ALERT SERVICE BULLETIN

429-19-43

Revision A, 2 April 2019

SUBJECT: MAIN ROTOR MAST ASSEMBLY 429-040-040-105
LOWER SPLINE INSPECTION, INTRODUCTION OF

Figure 1 - Mast Assembly and Splined Shaft Removal and Installation (Page 1 of 2)

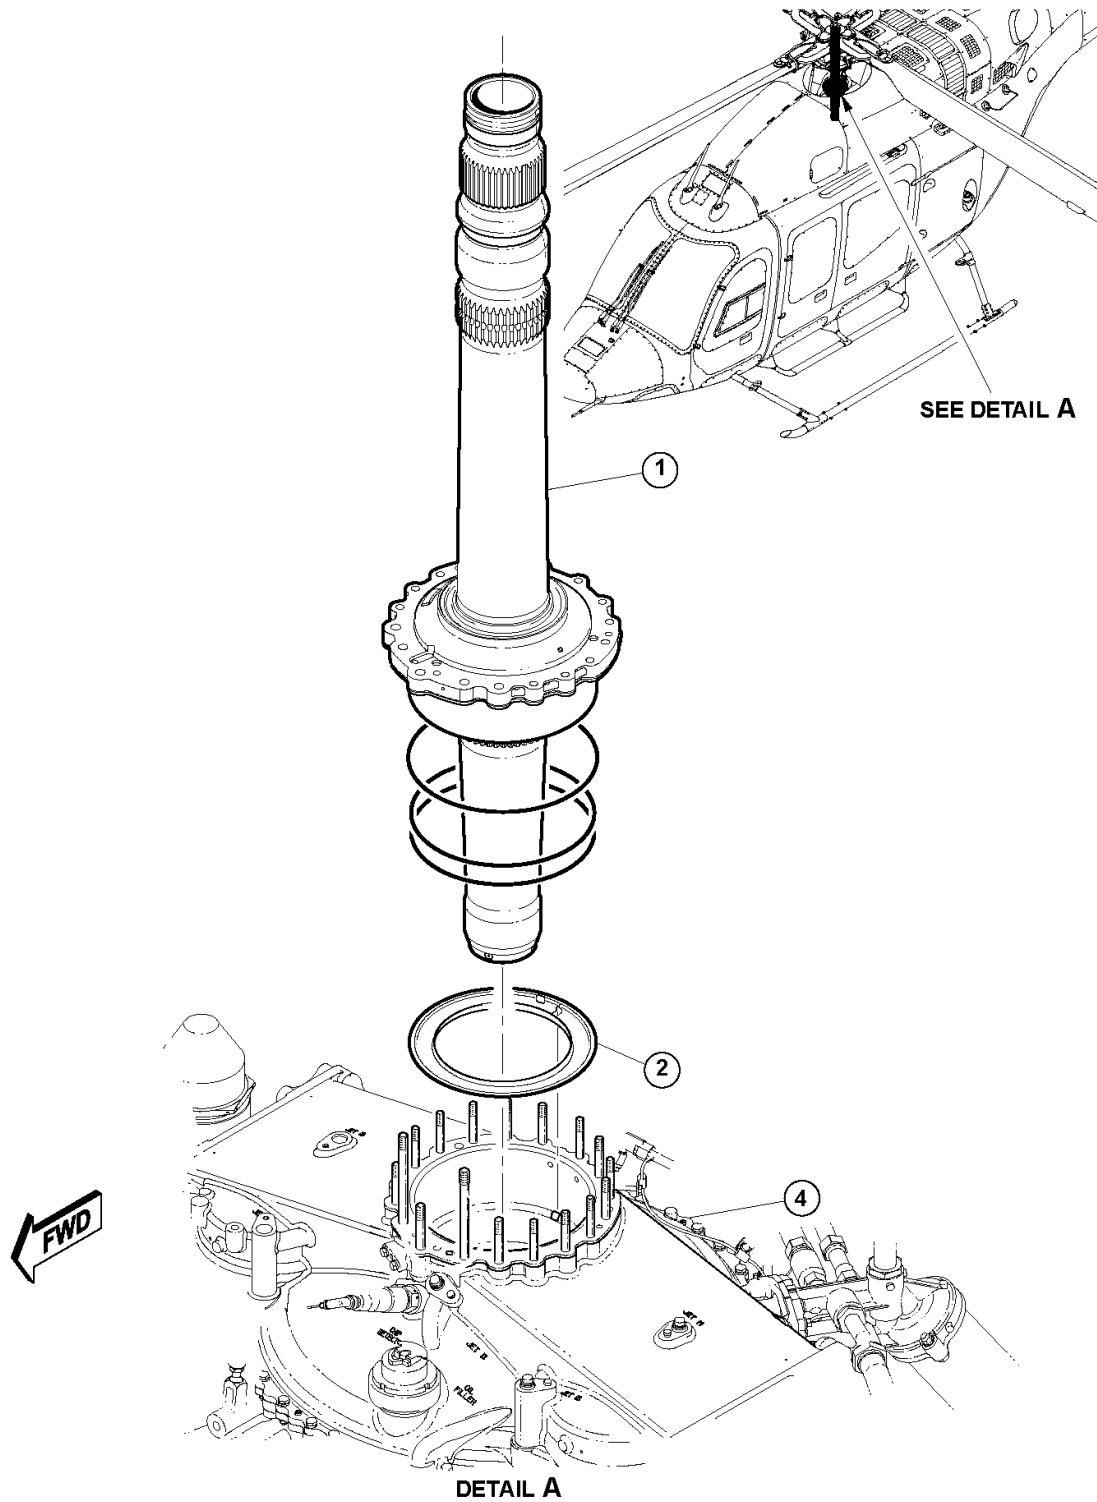
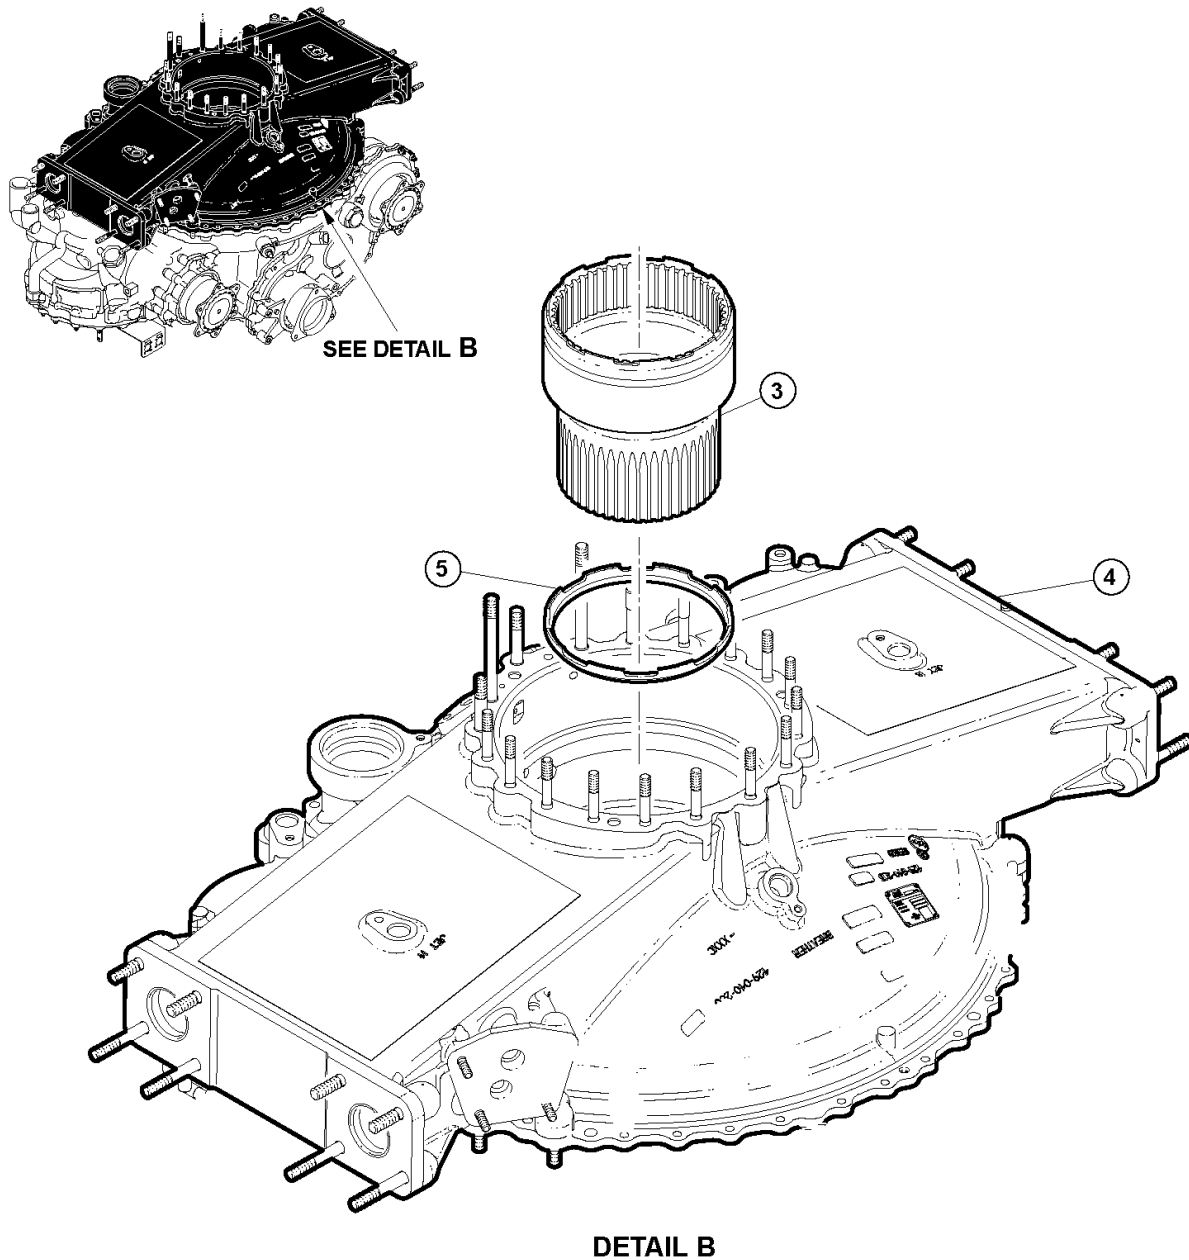
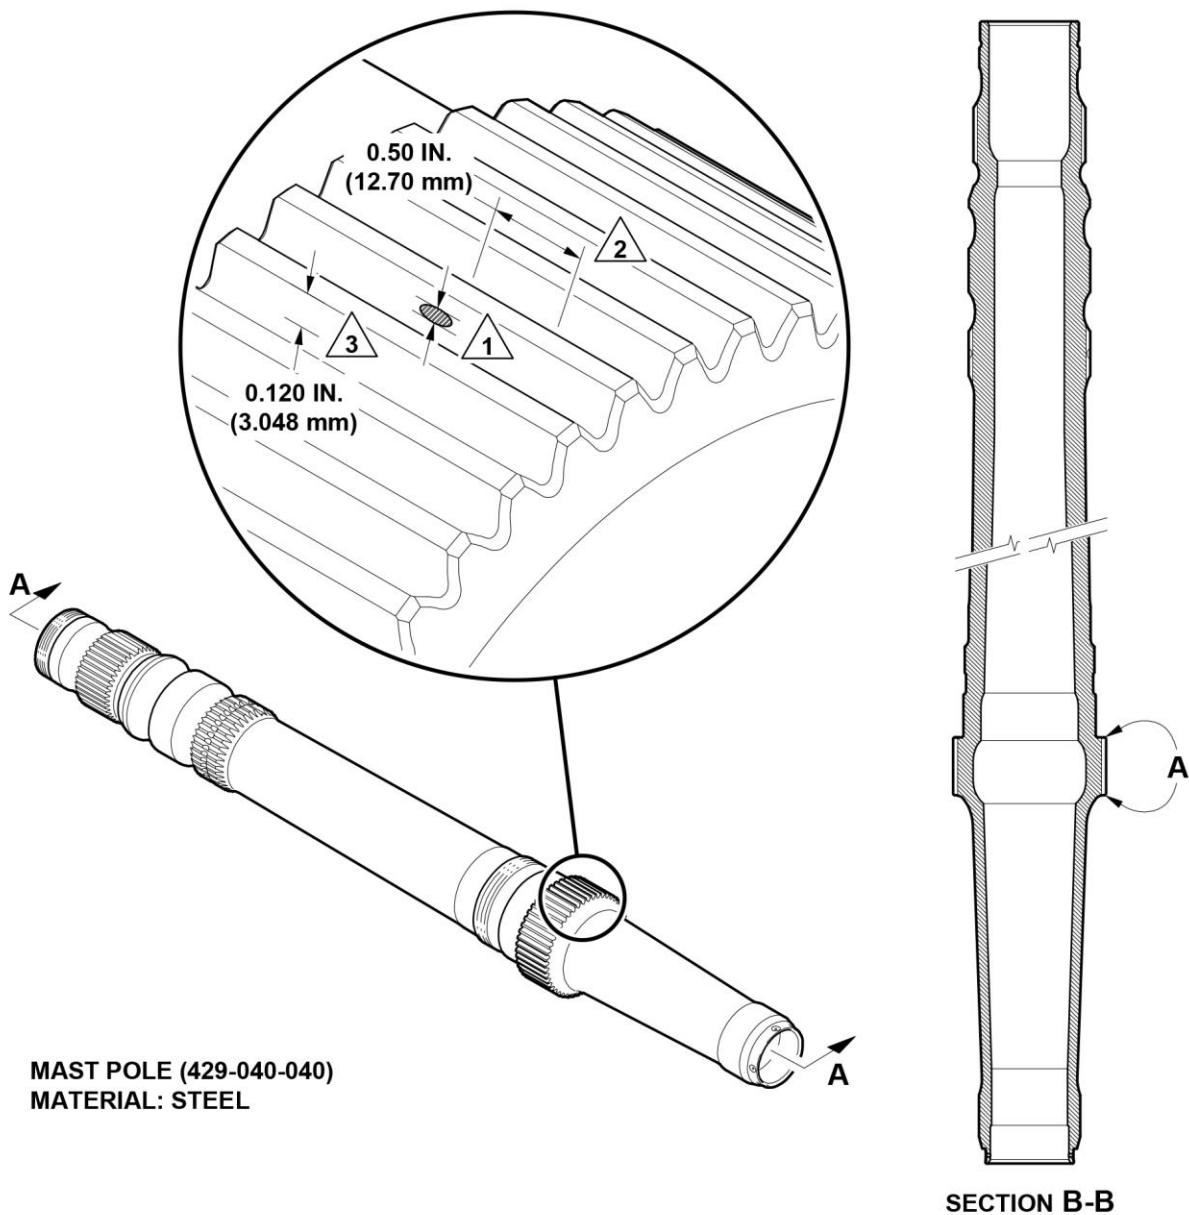
1. Prepare the helicopter for maintenance.
2. Remove the main rotor mast assembly (1, Figure 1) from the transmission assembly (4) (DMC-429-A-63-10-00-00A-520A-A).
3. Remove the debris pan (2) from the transmission assembly (4).
4. Remove splined adapter (3) from the transmission assembly (4).

7. Ensure that the splined shaft support (5) is in place prior to installing the splined shaft (3).
8. Install a serviceable splined shaft (3) by applying a film of lubricating oil (C-030) on the outer splines and sliding the splined shaft (3) into the main transmission bull gear splines.

9. Install a serviceable main rotor mast assembly (1) in the transmission assembly (4) (DMC-429-A-63-10-00-00A-720A-A).
10. Submit the inspection results that were logged in Table 1 to Product Support Engineering at productsupport@bellflight.com. **Make sure that the following is in the subject line of the e-mail:**

Figure 2 – Mast Pole Lower Drive Spline Mechanical Damage Limits

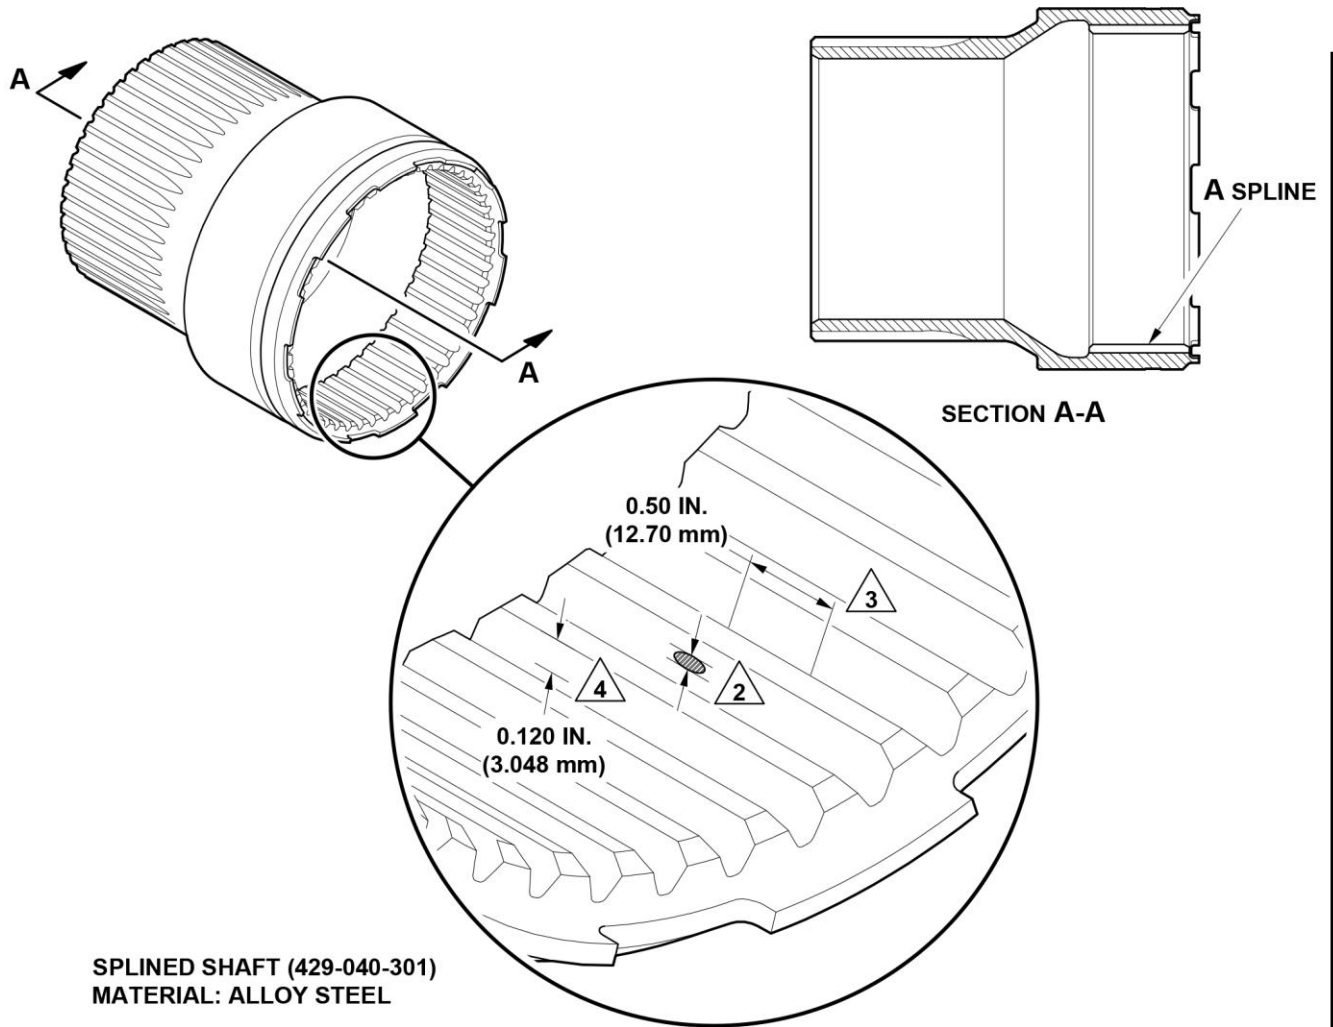
5. Inspect the main rotor mast assembly (1), paying particular attention to the lower drive splines. Refer to Figure 2 for damage limits.
 - a. Enter the results of the inspection in Table 1.

- b. Masts with drive spline damage beyond the limits in Figure 2 must be replaced with a serviceable 429-040-040-105S mast pole assembly.
6. Inspect the splined shaft (3) paying particular attention to the inner splines. Refer to Figure 3 for damage limits.

NO.	REF LTR	CHARACTERISTIC	INSPECTION METHOD	LIMIT
1.	A	Mechanical damage	Visual/ measure	Pitting or missing material on the tooth face up to 0.010 inch (0.254 mm) deep is allowable as long as any single pit found is no wider than 0.050 inch (1.270 mm) when measured perpendicularly to the tooth.

- 1 The width of a single pit is to be measured perpendicular to the tooth length.
- 2 Within any 0.50 inch (12.70 mm) length of the tooth, the pits shall not exceed 25% of the area of the tooth face.
- 3 Pits shall not extend below 0.120 inch (3.048 mm) from the top of the tooth.
